SUBSURFACE WASTEWATER DISPOSAL SYSTEM APPLICATION

City, Town, or Plantation: **AUGUSTA**
 St or Road: **87 OUTLET ROAD**
 Subdivision, Lot #: _____

SUBJECT: Approval, Replacement System Variance Request, Chadbourne property, Augusta

SUBSURFACE WASTEWATER DISPOSAL PLAN

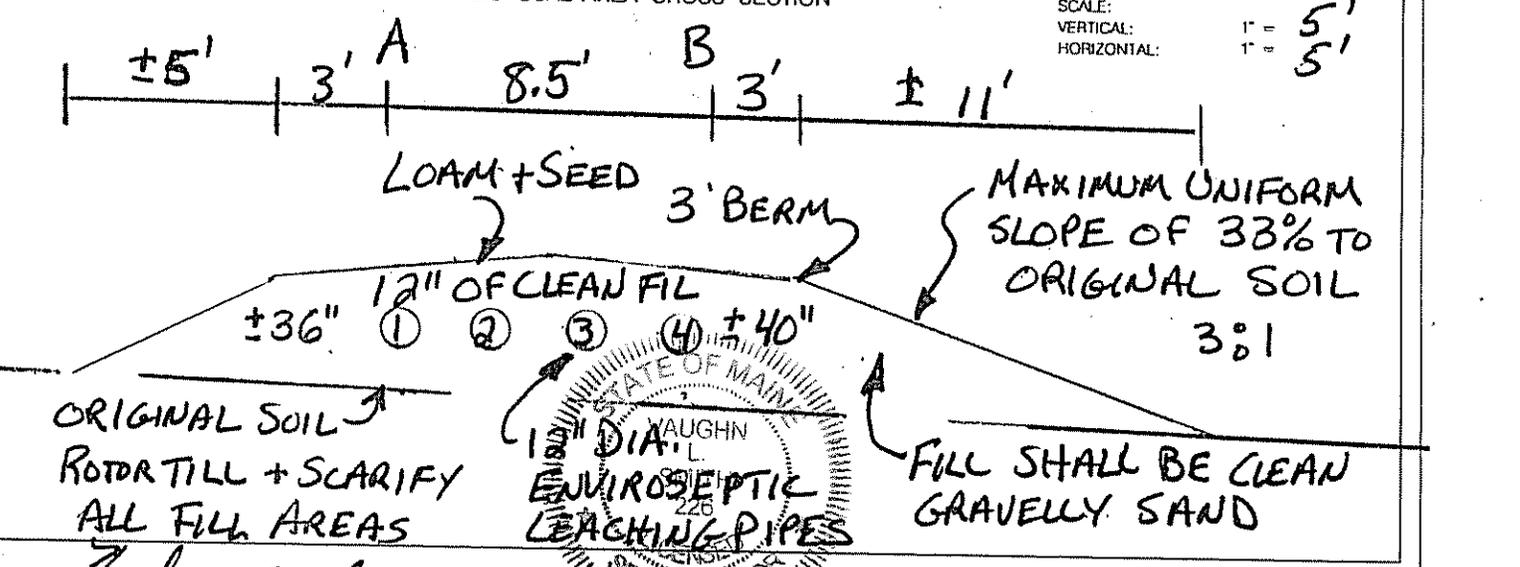
The Division has reviewed a replacement system variance request for the subject property. The state variance requested is to install the system with a setback distance reduction from your well to the disposal field of 50 feet and to the septic tank of 40 feet, a setback distance reduction from a major watercourse to the disposal field of 25 feet and to the septic tank of 25 feet, a reduction in depth to the seasonal high ground water table from 15 inches to 6 inches, and a fill extension grade to 3:1 as needed. As we understand the situation, the variance request has been submitted because topography and existing development limit the potential system location. The system design prepared by Vaughn Smith, SE, dated 11/14/2004 is otherwise found to be in compliance with the Maine Subsurface Wastewater Disposal Rules.

We approve the requested variance with the following requirements:

1. A permit for system installation is to be obtained from the Local Plumbing Inspector in advance of the start of system construction.
2. The system is to be installed in accordance with the submitted and approved system design. Should alterations to the design be required at the time of construction, the site evaluator is to be notified prior to making any changes.
3. The contractor is to scarify the soils under the fill extensions to create a transitional zone more compatible with the disposal field area.
